# Service Bulletin

AUGUST

1959

NO. 349

FIG. 1

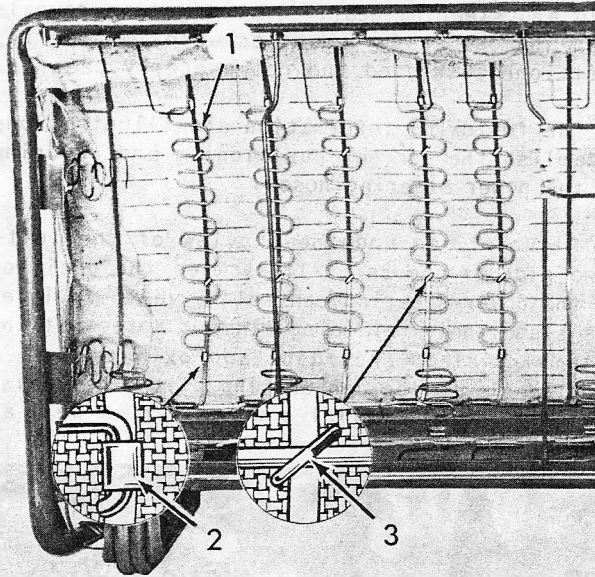
Some seat cushion and seat back sagging has occurred on 1959 cars; especially on taxicab and severe service vehicles. To correct this sagging condition a Front Seat Cushion or Back Heavy Duty Kit AC-2986 (Part No. 1333999) has been released for service. This kit consists of Reinforcing Elements, Part No. 1333896, Clips, Part No. 1333553, and instructions for installing the elements in the seat cushion and seat back. See Fig. 1

FIG. 2

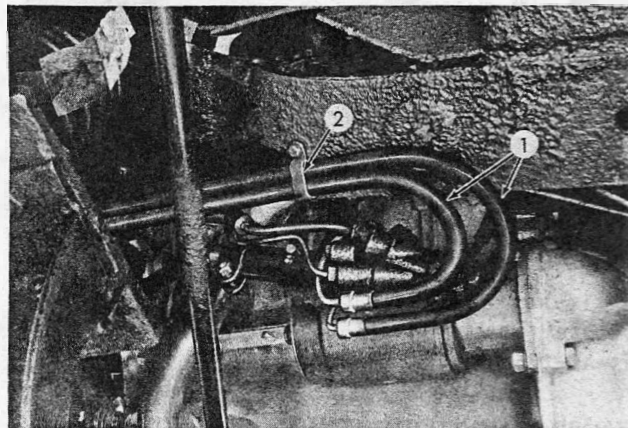
We have received reports of power steering hoses coming in contact with the exhaust manifold and steering gear. Investigation reveals that in most cases the hoses were improperly positioned, twisted and not properly secured.

Figure 2, an underneath view of the left-hand side of the car, illustrates the position of the power steering control valve-to-cylinder hoses and their retaining clamp. Note that the retaining clamp should be approximately at a right angle to the center line of the car, also that the hoses parallel one another as well as the frame.

FIG. 3

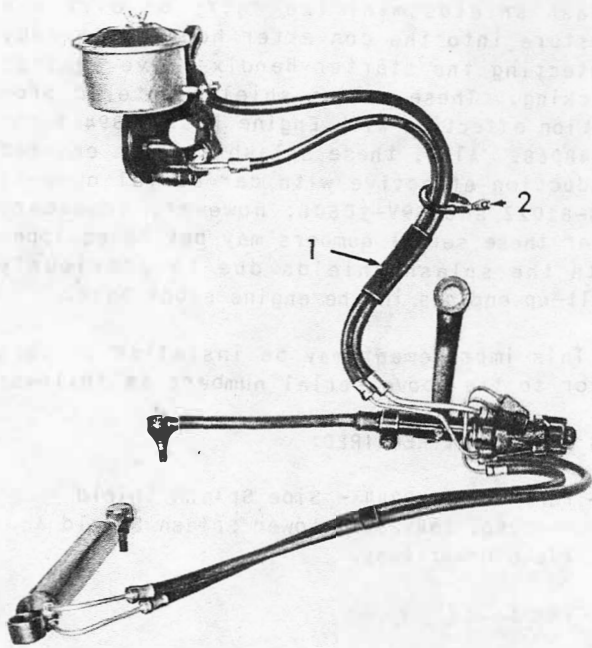
The relative position of the power steering pump, control valve assembly, pitman arm and reach rod, and the power steering cylinder are shown in Fig. 3. This illustration reproduces, as closely as possible, the relative positioning of these units and hose assemblies in their installed positions. The protective grommet on the power steering pump-to-control valve hoses should be located approximately 7" from the lower end of the hoses. This is necessary to prevent any scuffing of the hoses by the steering gear housing. The spring wire and sleeve assembly must be wrapped around the two pump-to-control valve hoses approximately 3" above the protective grommet, with both ends of the spring secured to the retainer clip

FIG. 4

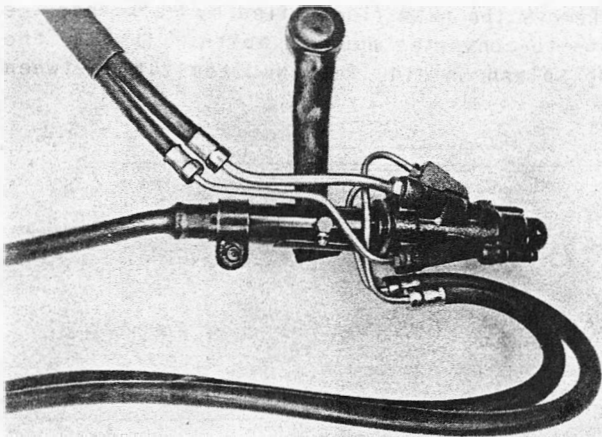
A close-up side view of the control valve assembly, (see Fig. 4), shows the correct positioning of the hose and tube assemblies. Note that the control valve-to-power steering cylinder hoses are parallel and should be secured by the frame clip (see Fig. 2) so that the hoses do not droop downward at the looped portion of the hoses.

FIG. 5

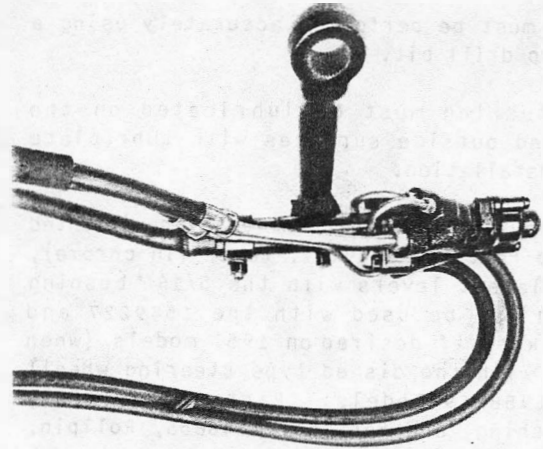
The top view shown in Fig. 5, illustrates the correct position of the power steering pump-to-control valve hose and tube assemblies, and the control valve-to-cylinder hose and tube assemblies.

FIG. 6

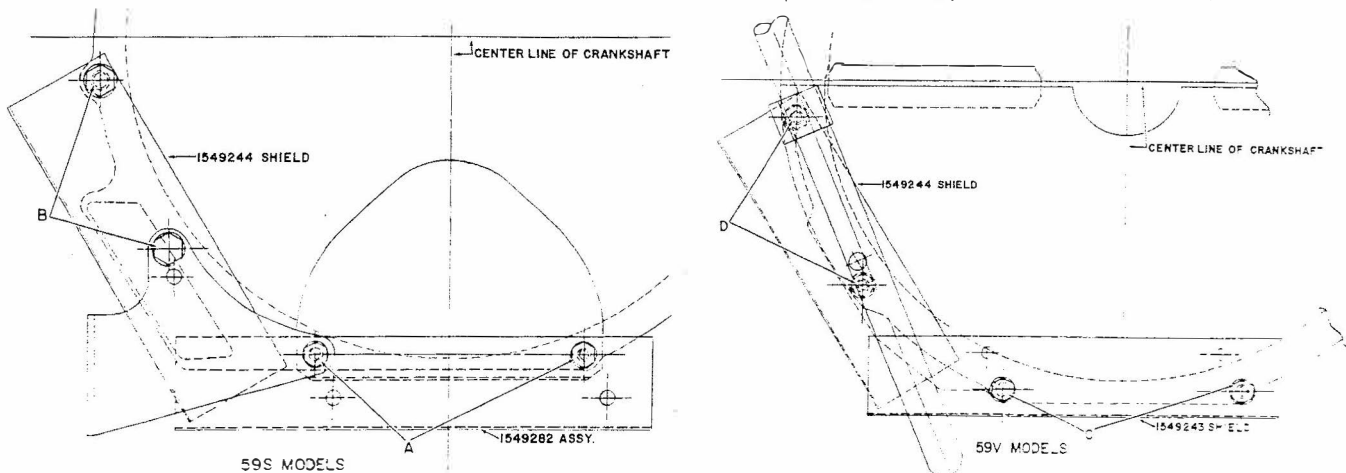
Two new splash shields have been added to cars equipped with an automatic transmission. The combination of the new, lower splash shield assembly and the new side splash shield protects the converter air cooling system opening in the housing and also the torque converter drain hole in the converter housing. These

- 1) Remove the two bottom engine rear plate-to-converter housing cap screws (identified by "A" in Fig. 6). Remove the engine rear plate cover and clip assembly and discard.
- 2) Remove the two engine rear plate-to-converter housing screws identified by "B" in Fig. 6. Install Part No. 1549244, Side Splash Shield, and reinstall the cap screws. This shield should be installed between the exhaust pipe support bracket and the engine rear plate.
- 3) Install the Lower Splash Shield and Plate Cover Assembly, Part No. 1549282 and secure with the cap screw identified by "A".

- 1) Remove the nuts (identified by "D") from the plate-to-converter housing bolts. Install the Side Splash Shield, Part No. 1549244, between

2) Remove the nuts identified by "C" from the bottom torque converter housing-to-plate bolts. Install the Lower Splash Shield, Part No. 1549243, on the bolts and reinstall the nuts.

FIG. 7

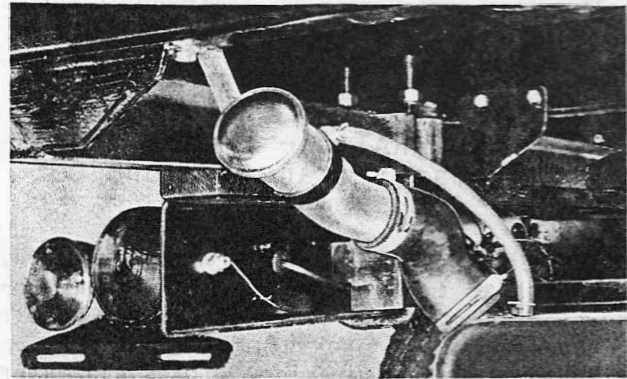
It has come to our attention that when a stake or platform body is installed on a 4-wheel drive truck after production some difficulty may be experienced in filling the gasoline tank.

This difficulty can be corrected by modifying the gasoline tank filler neck as shown in Fig. 7.

FIG. 8

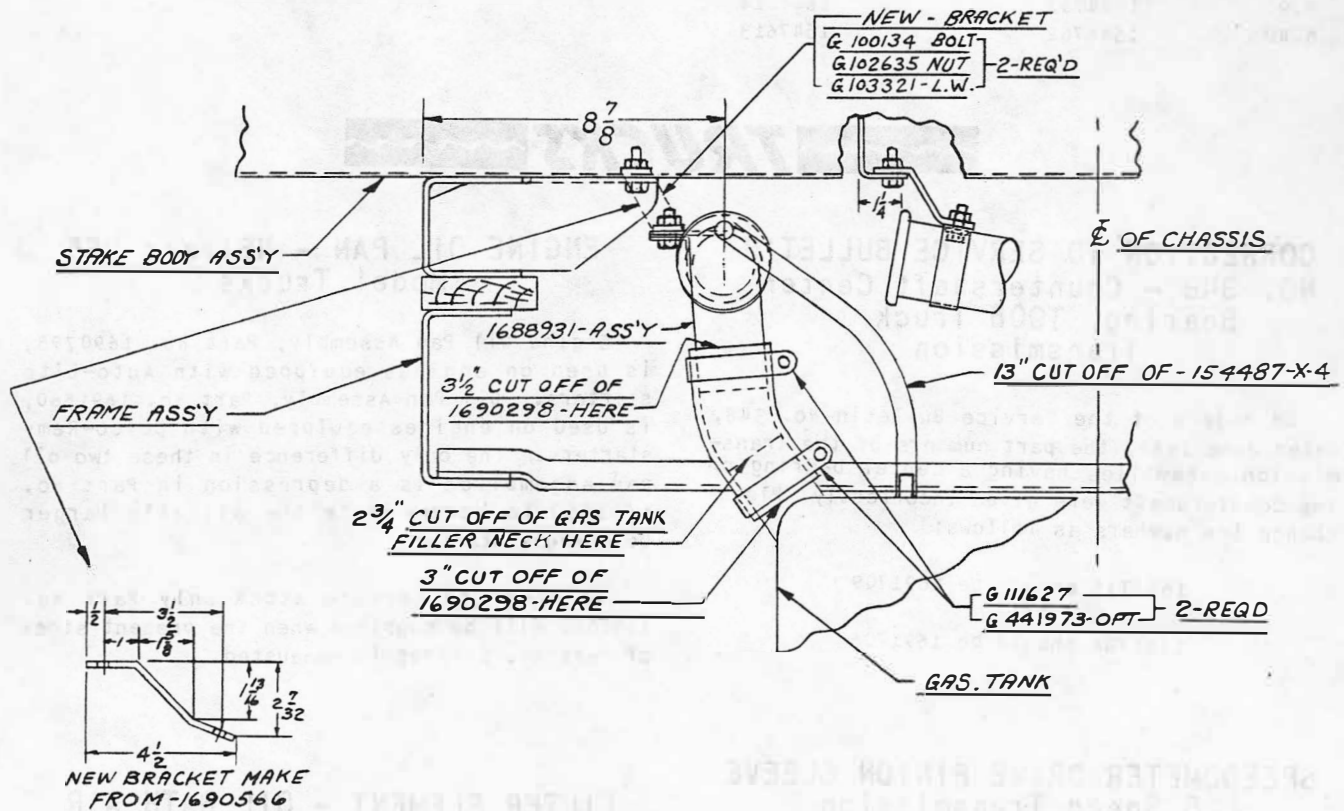
Complete details for the modification are shown in Fig. 8. All parts listed are available through your Parts Depot.
